UNITED STATES PATENT AND TRADEMARK OFFICE

Office Action Summary

10/624,164

FAKHOURY ET AL.

WHEEL HUB

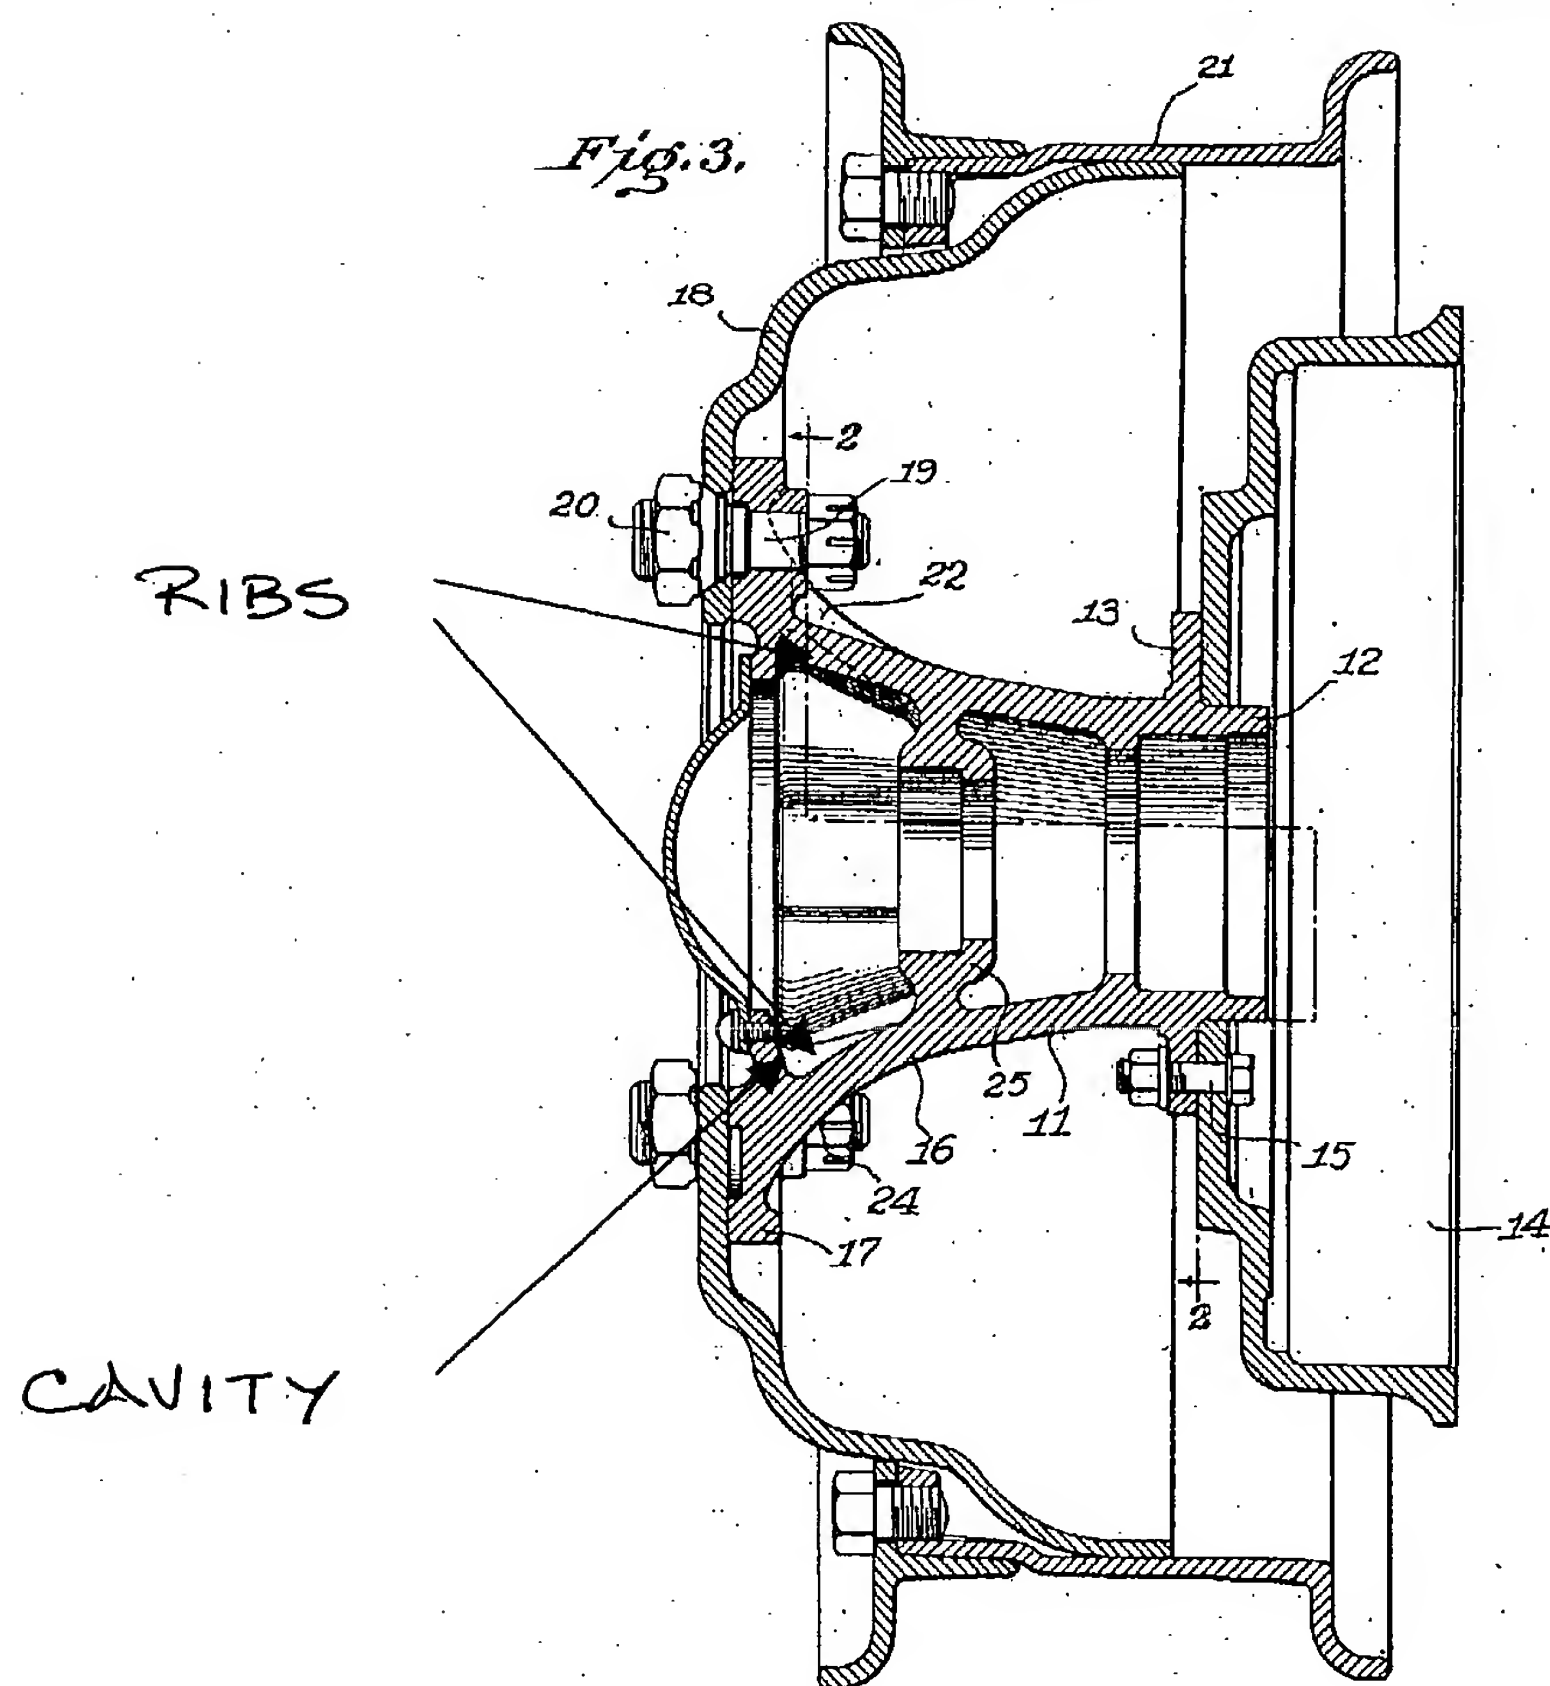
Eksergian (previously cited, newly applied) discloses a one-piece wheel hub comprising a main body 11 having an axial bore, a flange 17 extending axially from the main body, at least one rib (shown at the end of the lead line for the reference character 23 in figure 1 and at 27 in figure 2. As shown in figure 3, the rib is disposed in a cavity formed at the intersection of the main body and the flange. See below figure 3 of Eksergian reproduced on the next page.

As shown in figure 1, the rib is tapered in width, and the inboard side of the flange defines a smooth continuous curve. With respect to claim 16, the rib supports the outboard end of the main body.
